FORTISBC INC.
OTR PROJECT CPCN

***Re: An Application for a CPCN for the Okanagan Transmission Reinforcement (OTR)
Project No. 3698488 - Information Requests***

Project No. 3698488: Okanagan Transmission Reinforcement (OTR) Project
Requestor Name: BC Utilities Commission
Information Request No: 3
To: FortisBC Inc.
Request Date: April 24, 2008
Response Date: May 13, 2008

FORTIS BC - OTR PROJECT OVERVIEW WITH WILTSE ROUTES ORTHOPHOTO MAP	
DRAWING NUMBER	REV
BCUC IR 93.1	A

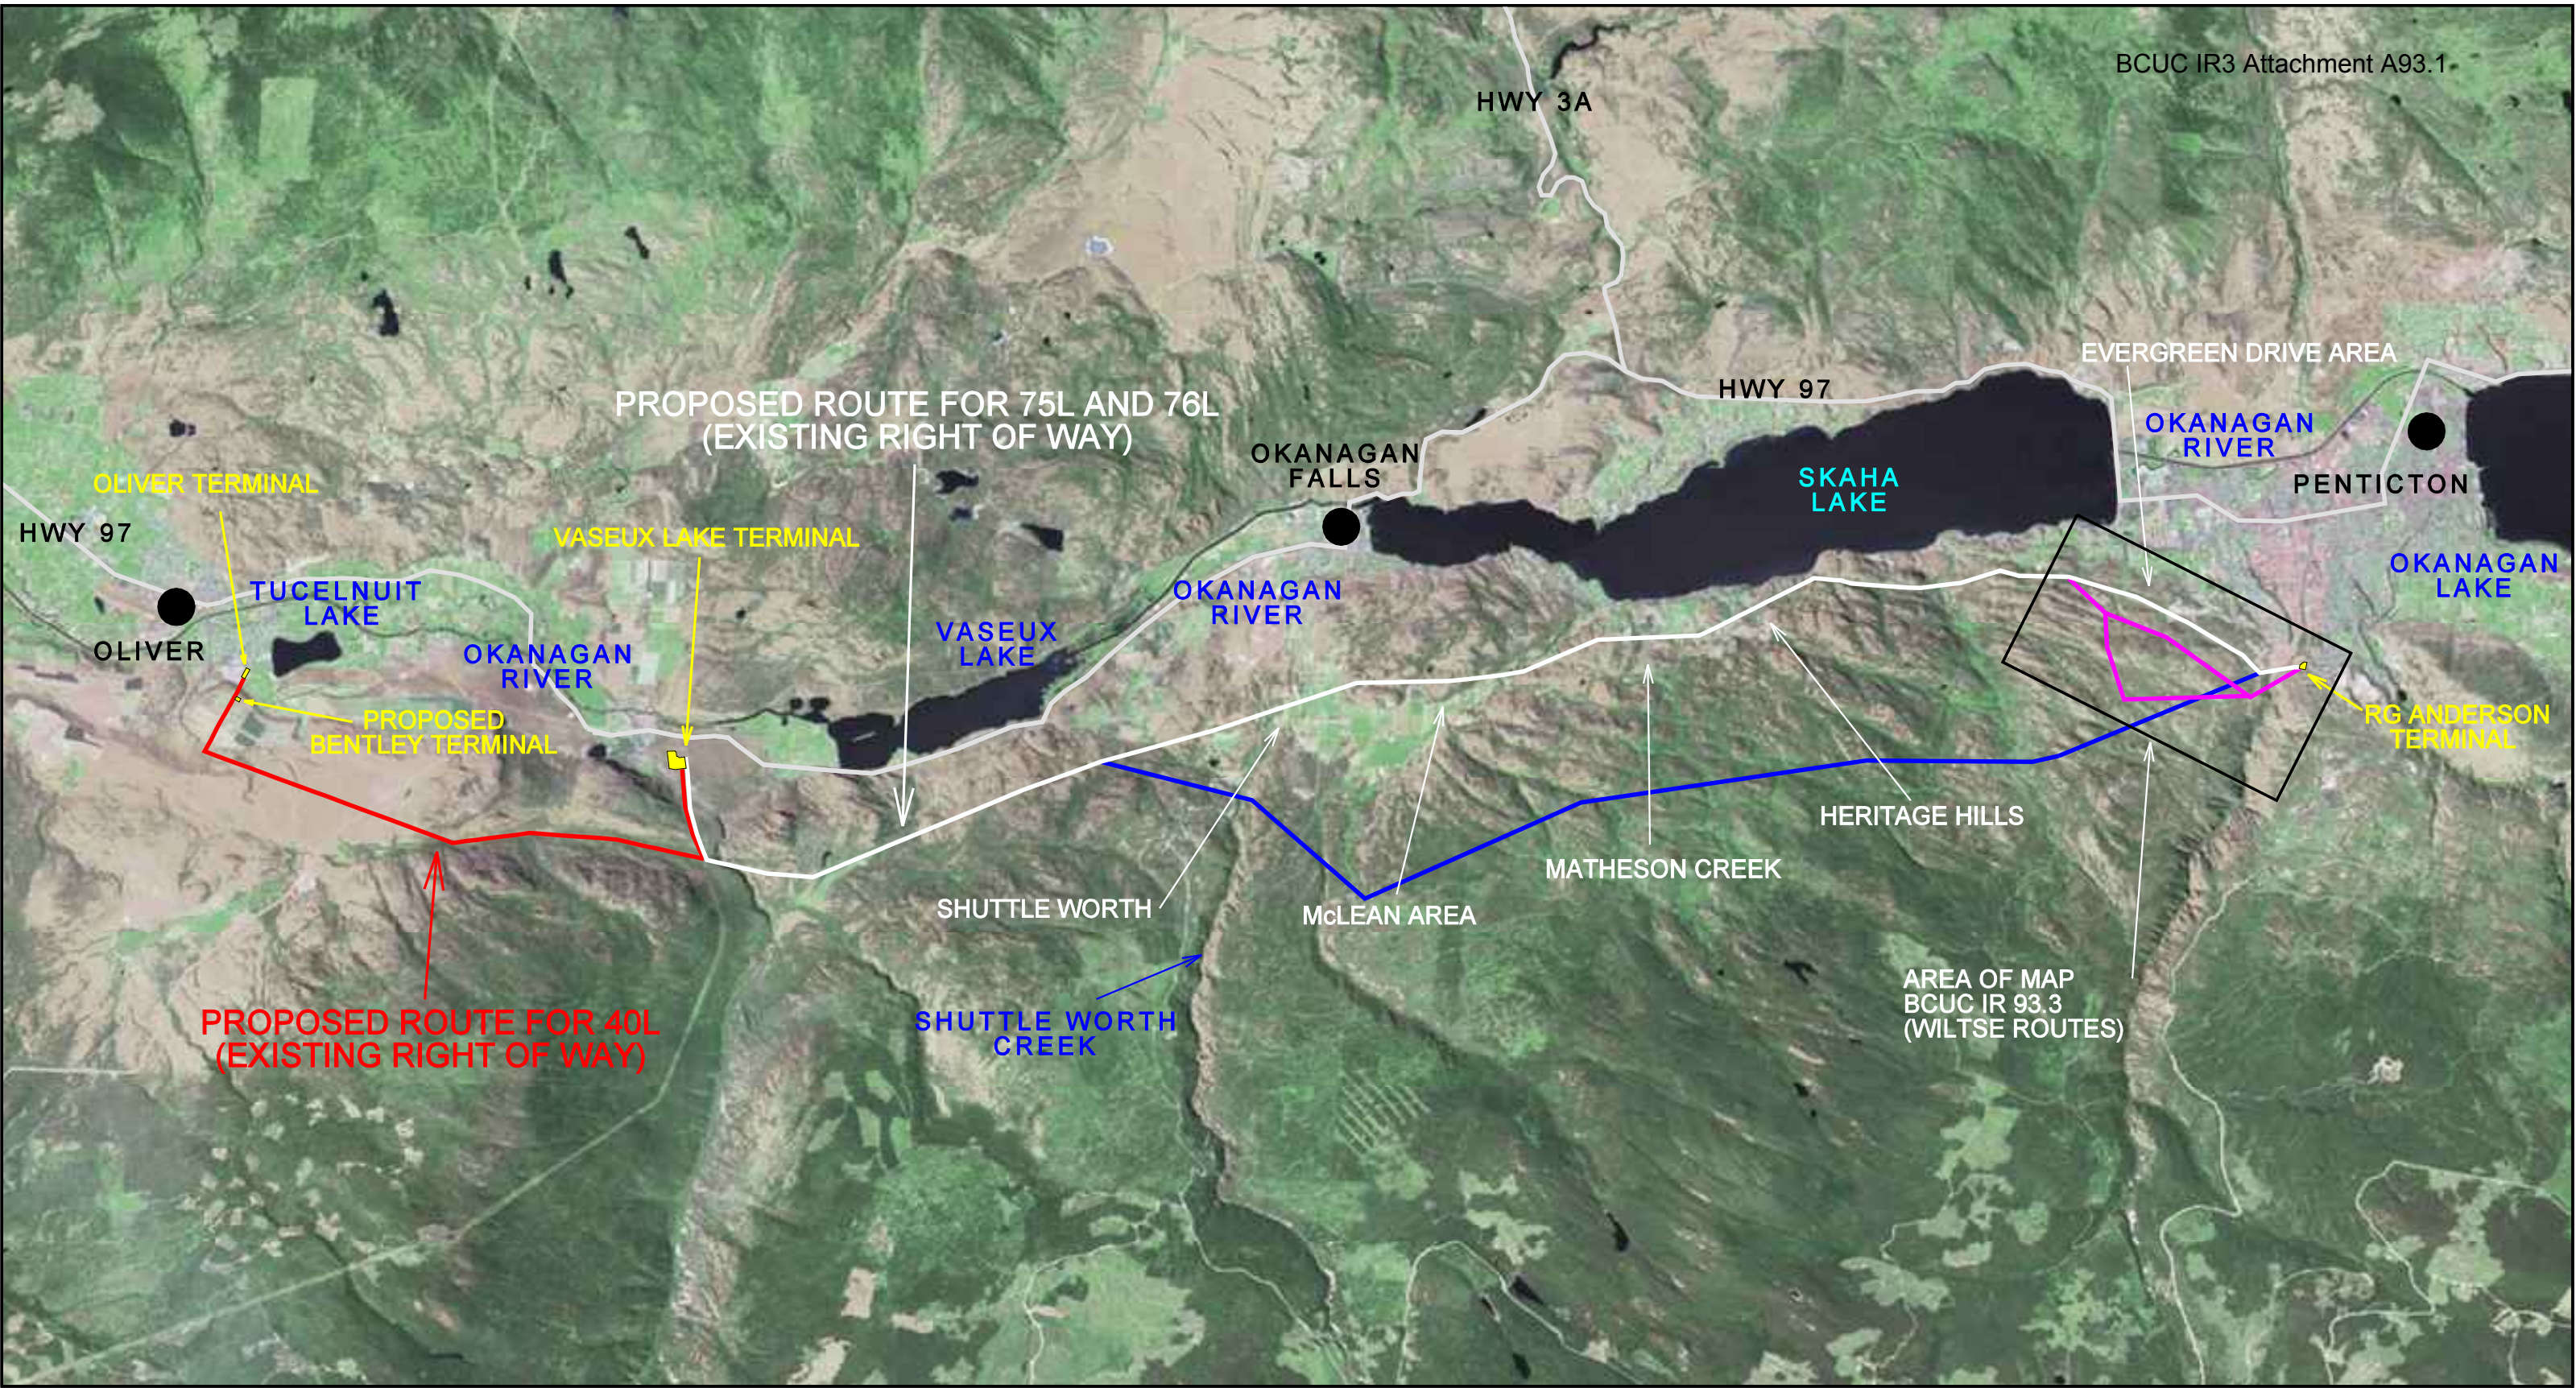
Q93.1 Why did FortisBC include 2A rather than the Wiltse proposed route (or a comparable alternative) in its CPCN Application?

A93.1 It is the view of FortisBC that the routes proposed by Wiltse Holdings Inc. ("Wiltse") are not, in a material way, "alternatives" to the OTR Project preferred route. As seen in BCUC IR3 Attachment A93.1 following, all but approximately 4.3 kilometers of the line would remain on the existing right-of-way.

FortisBC investigated alternatives to the existing right-of-way at the request of stakeholders during the public consultation process. Residents of the Heritage Hills, McLean Creek and Shuttleworth Creek areas were among those stating a preference for a higher elevation route. Unlike Alternative 2A, the Wiltse routes do not address the concerns of residents in those areas.

BCUC A103.3 b - re BCUC Figure A57.7:
75 Line and 76 Line Magnetic Field Vs Distance from Centre of Right of Way
(161 kV Cross Section A, 230 kV Cross Section C)

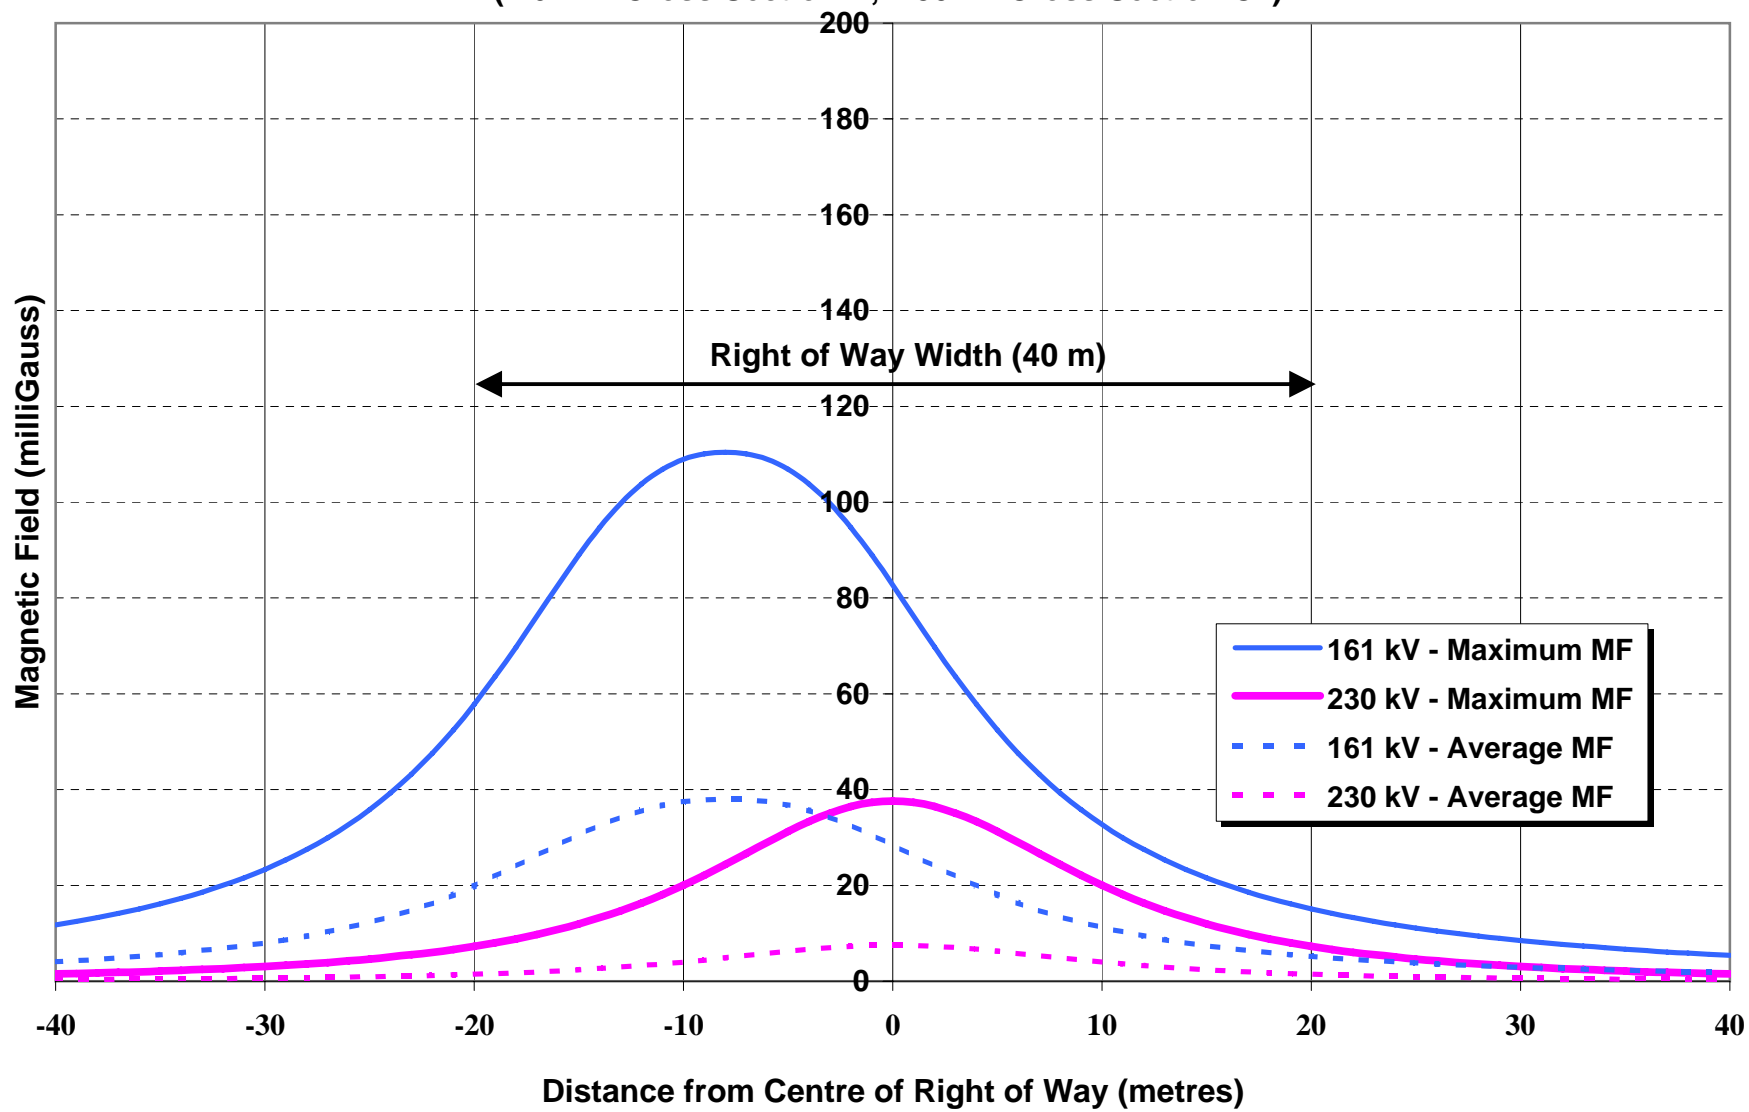
Q103.1 The responses to BCUC IR 57.6 and BCOAPO IR 8.3 show maximum case EMF highest readings on the ROW of 54 and 46 mG for Cross Section C (Alternative 1A) and Cross Section E (Alternative 1B), respectively. KAROW Attachment A9 shows maximum case EMF highest readings of 37.63 and 53.34 mG for Alternative 1A and Alternative 1B, respectively. The response to Karow IR 9 states that the calculations are based on opposing phasing configuration to mitigate opposing fields. Please confirm that FortisBC intends to design the transmission lines under any alternatives so as to mitigate magnetic fields to the extent it is reasonably possible to do so.

15 A103.3 Based on the response to Q103.2 above, the estimates of EMF are included
16 in BCUC IR3 Attachment A103.3 as follows:

18 BCUC A103.3 b - re BCUC Figure A57.7

BCUC IR3 Figure A105.2

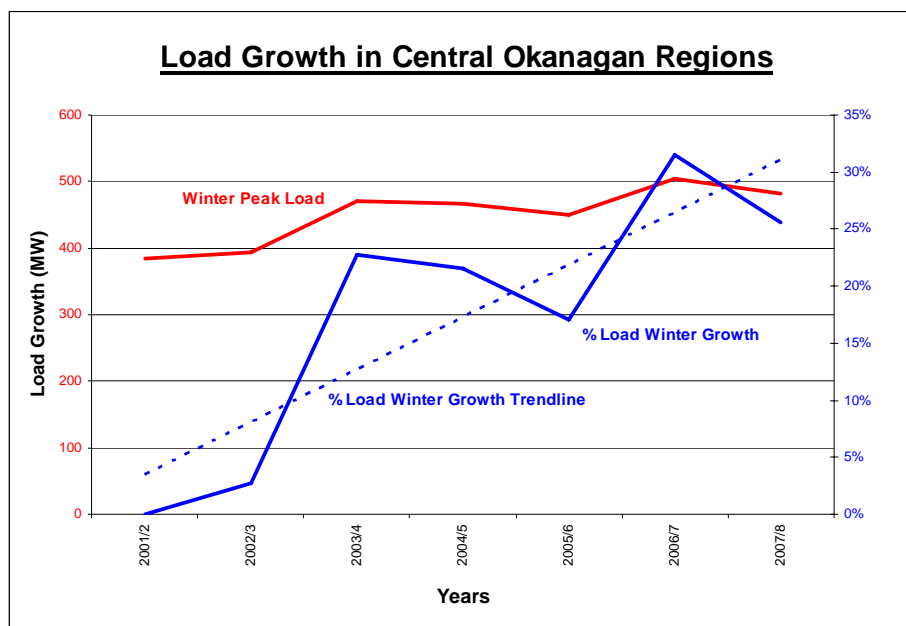
Q105.2 If actual load data are available for 2007/08, please provide a version of Figure A85.4 incorporating this additional data, and include this data in the table filed in response to the previous question.

A105.2 Please see BCUC IR3 Figure A105.2 below.

**Karow IR2 A4 Figure A - Magnetic Field Profile Heritage Hills
- Existing 161 kV Line**

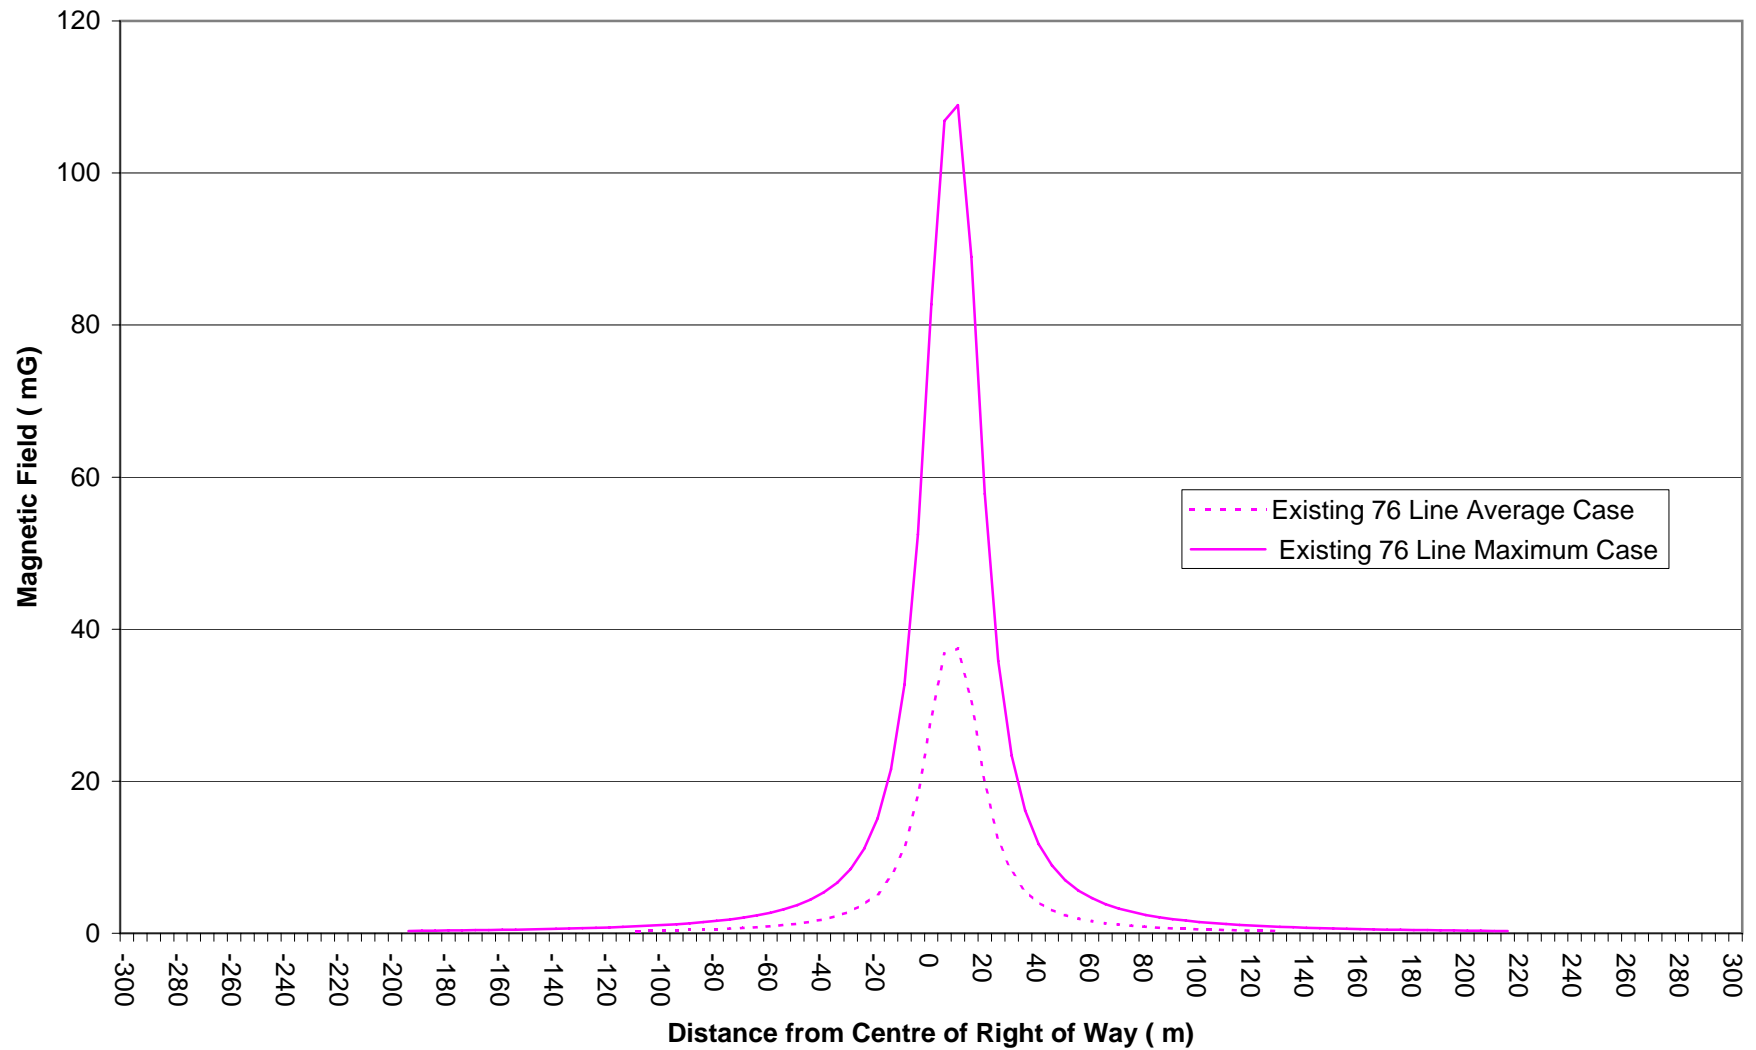
- 1 **Q4. Please provide magnetic field profile (as far as to the 0.3 milliGauss border)**
2 **for medium and maximum load on both sides of the proposed to be**
3 **upgraded line in the Heritage Hills area, this for every 5 meters from centre**
4 **of line a present time and after upgrade.**
- 5 **A4. Please see Karow IR2 Attachment A4 - Figures A to E for the requested profiles**
6 **down to 0.3 mG for the Existing Line, and for Alternatives 1A, 1B and 1C.**
